Addendum #3

Directorate of Facilities Engineering

21 January 2022

Bog Brook Kitchen Renovation, Gilead, Maine, Project Number 23TR19-603-D, BGS Project Number 3195, Bid Number 22-017.

DOOR/ROOM/SIGNAGE SCHEDULES AND DOOR/WINDOW TYPES

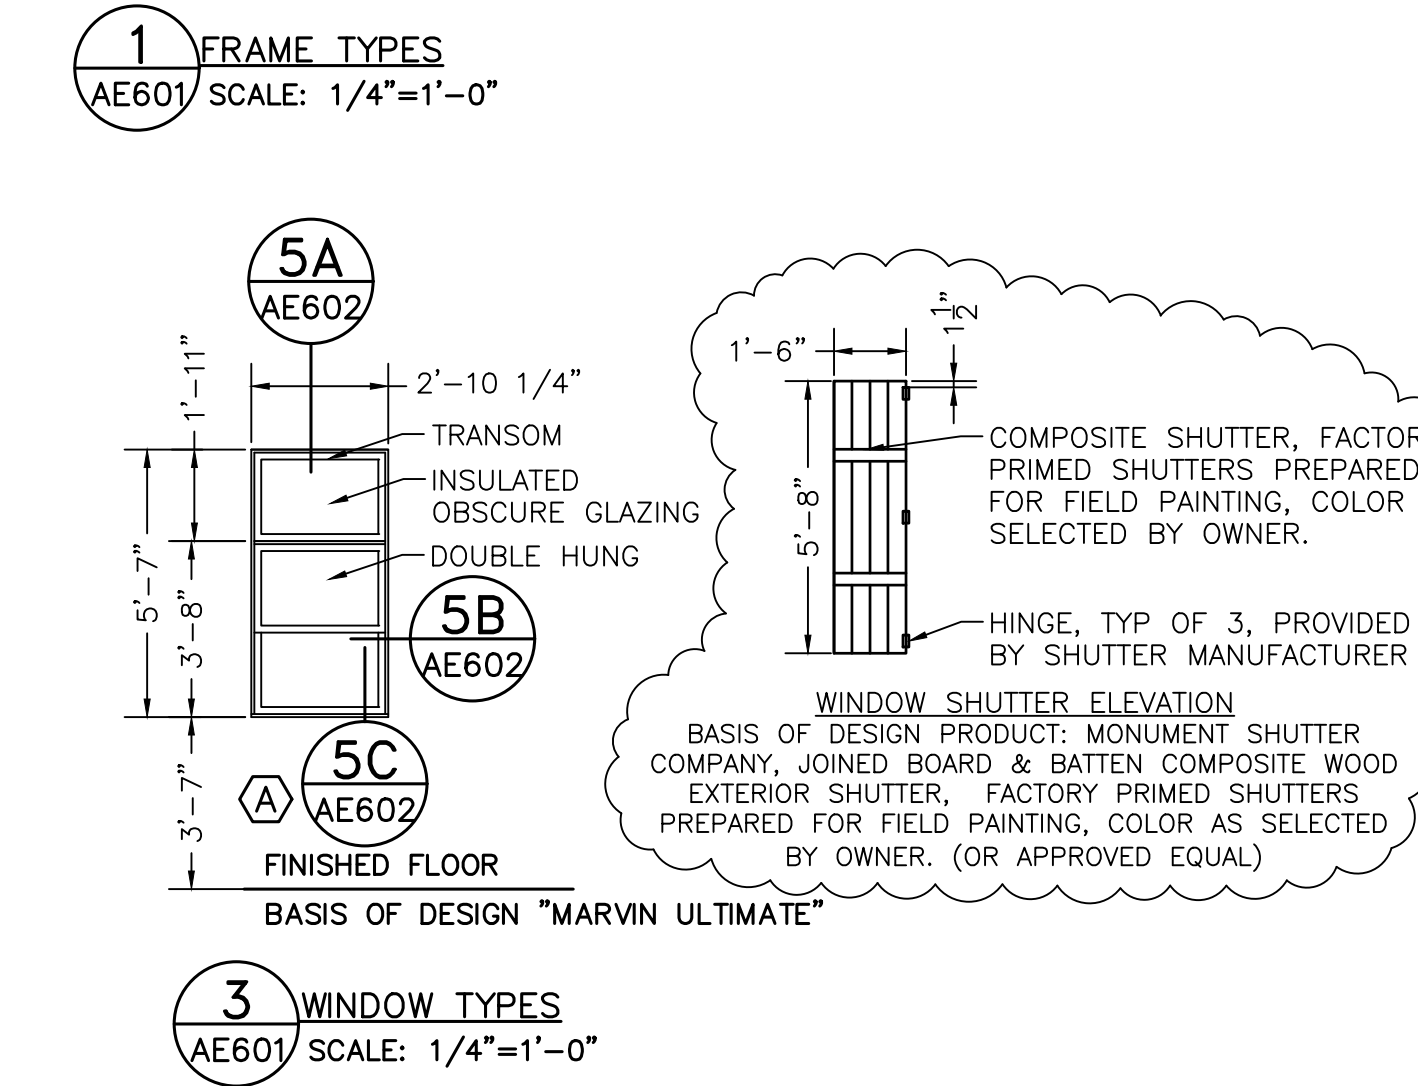
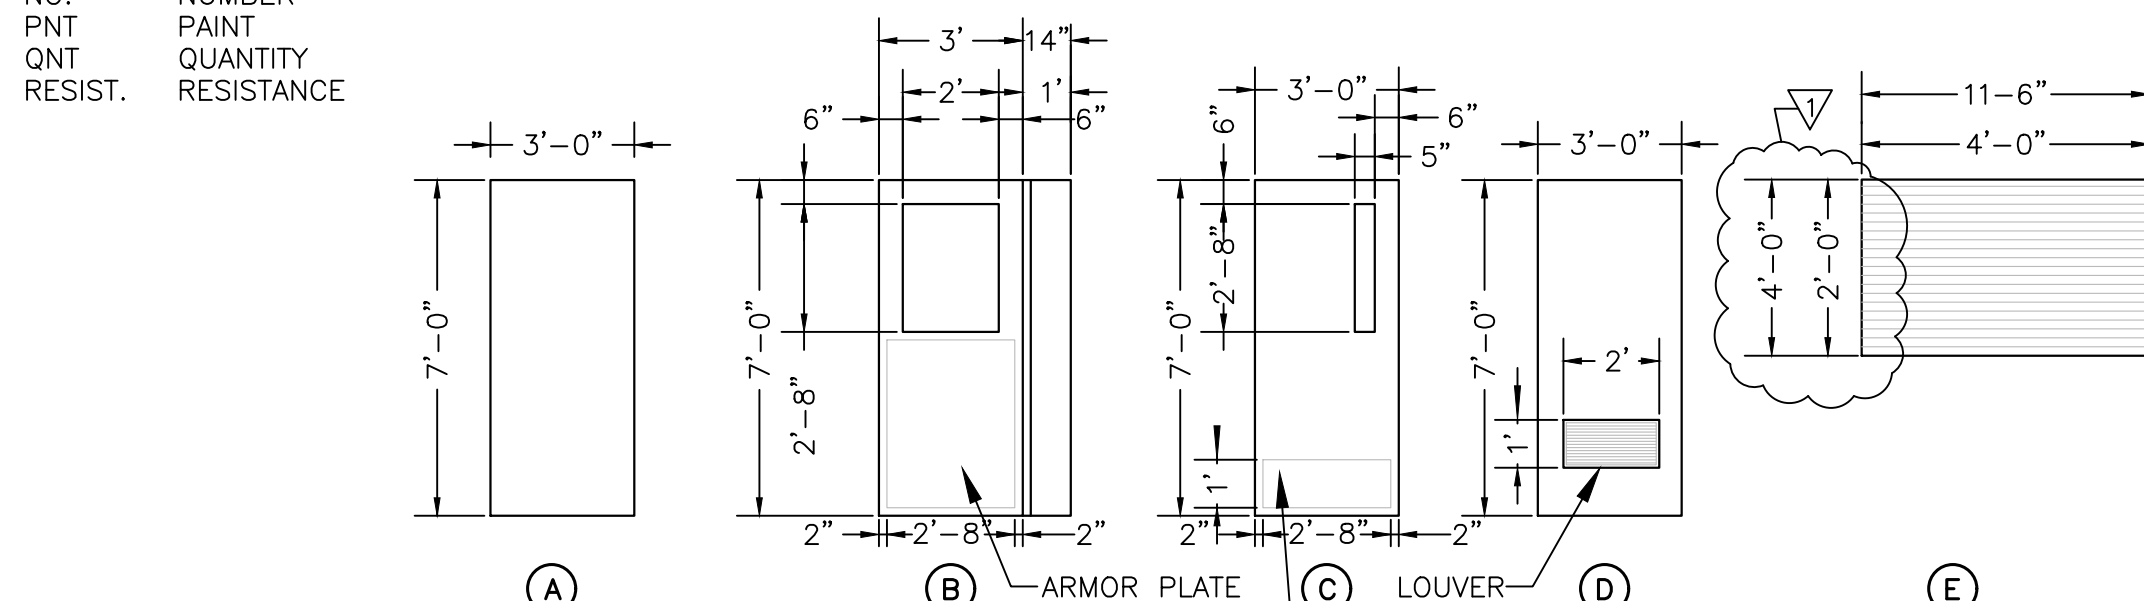
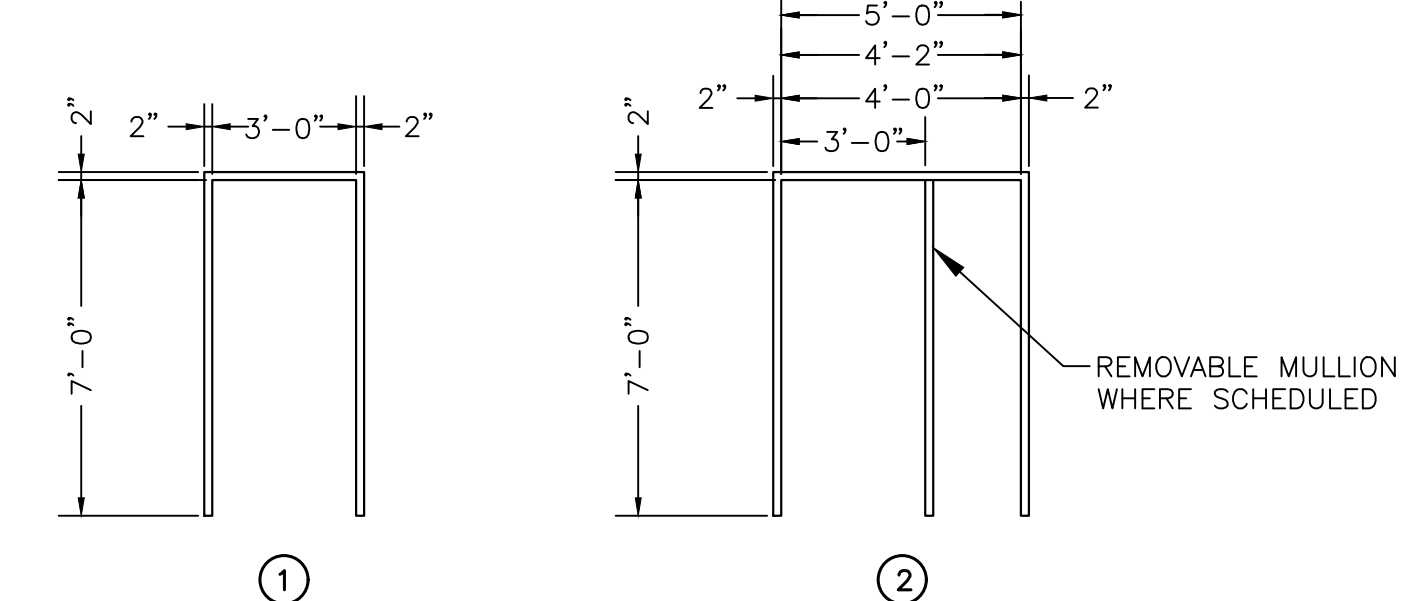
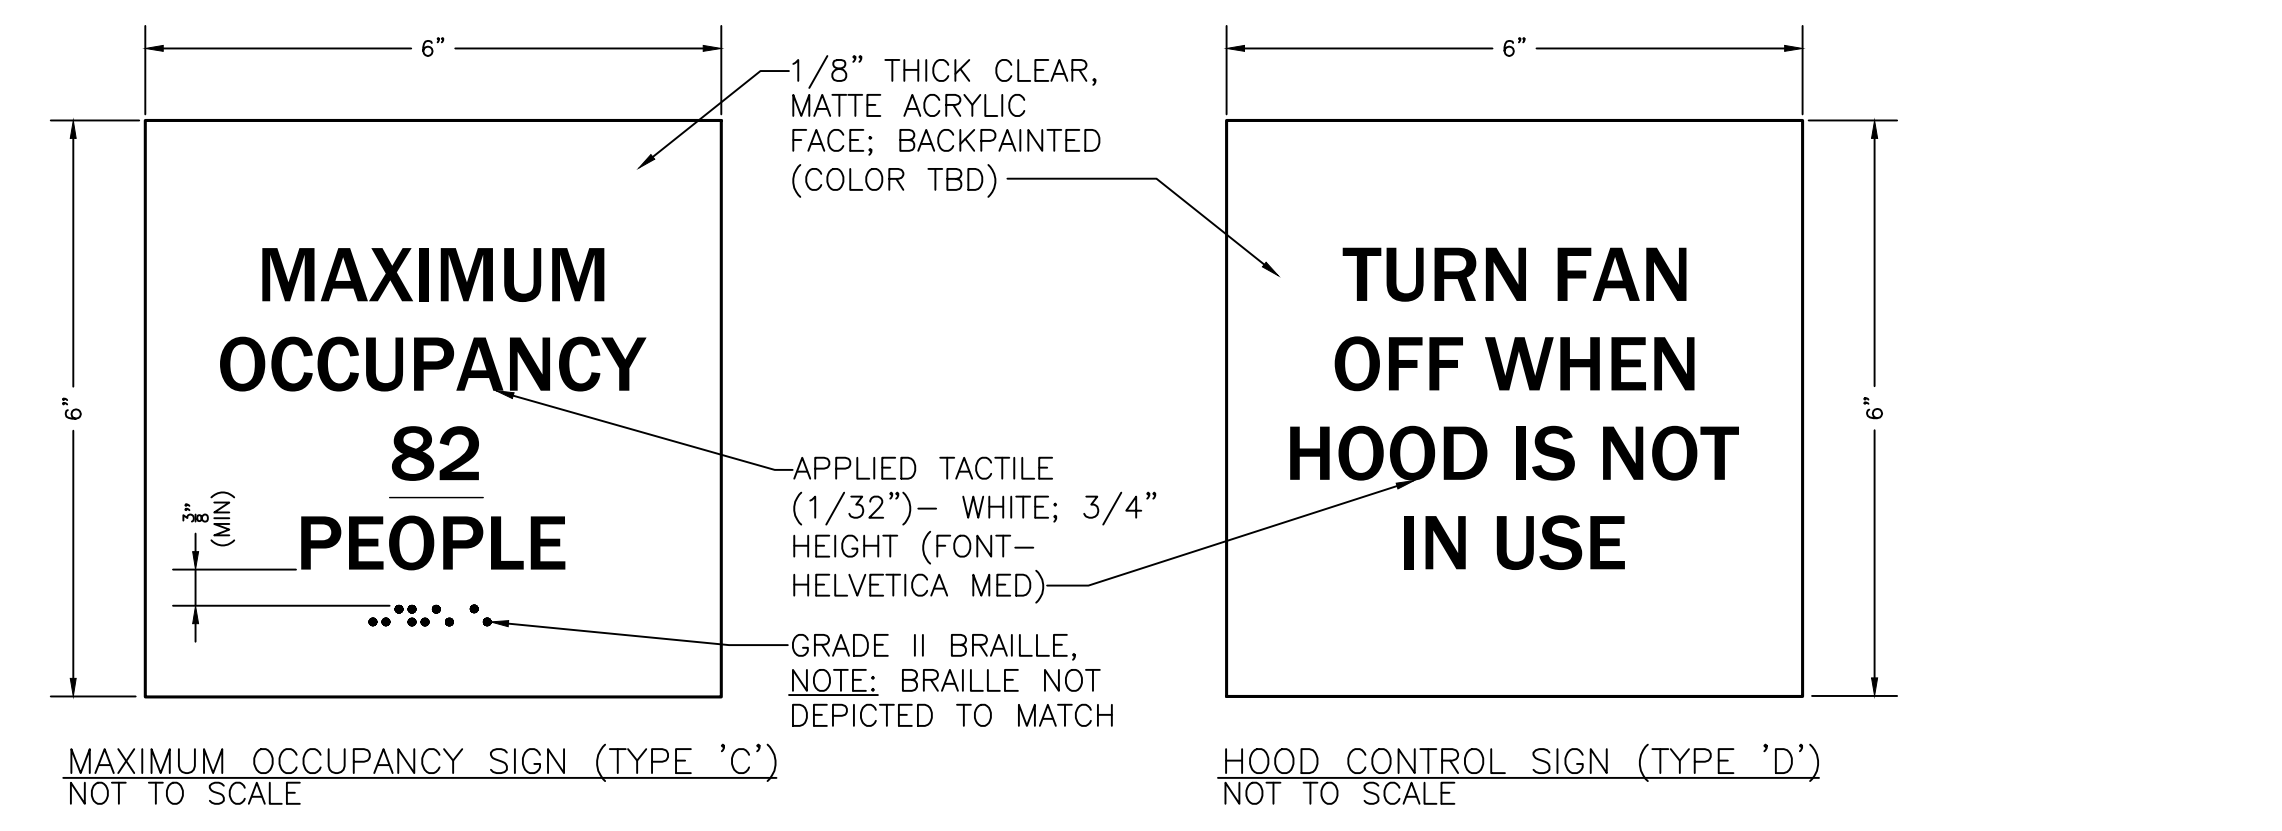
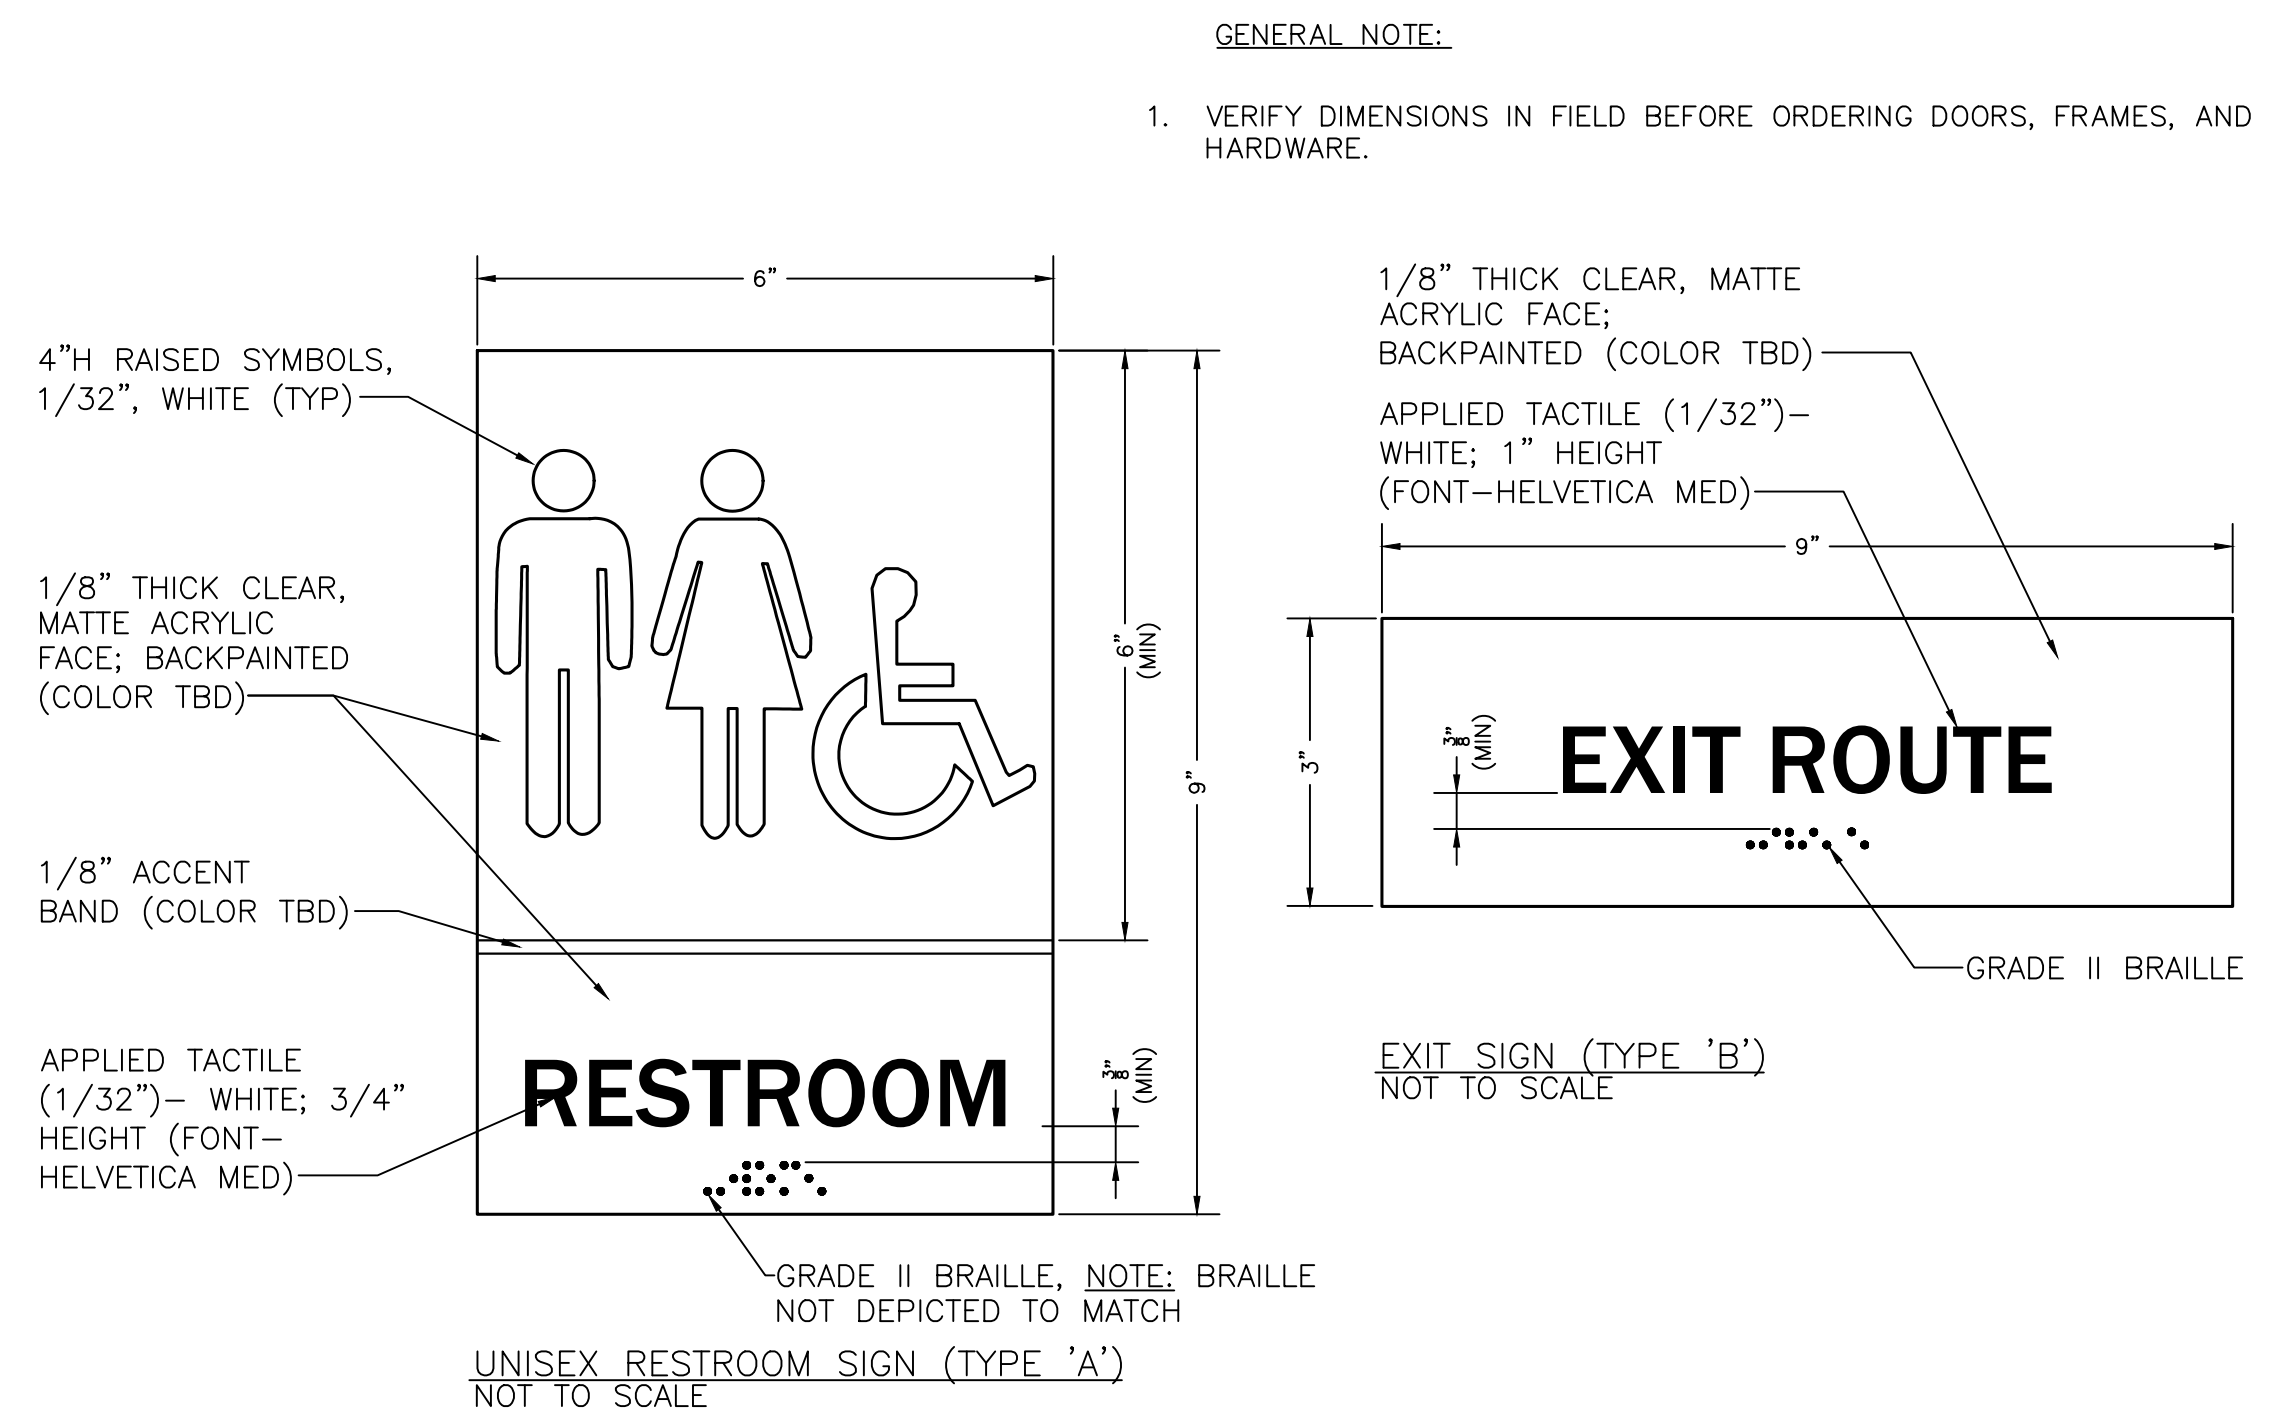
Answer: No new insulation is called for on the inside face of foundation walls.
11. **Question:** Please provide a specification for the aluminum shutters shown on the exterior elevation drawings.

Answer: Basis of Design Aluminum Shutter is noted on Detail 3/AE601. That aluminum shutter is no longer available. Provide Basis of Design Product or Approved Equal: Monument Shutter Company, Joined Board & Batten Composite Wood Exterior Shutter, Factory primed shutters prepared for field painting, color as selected by Owner.
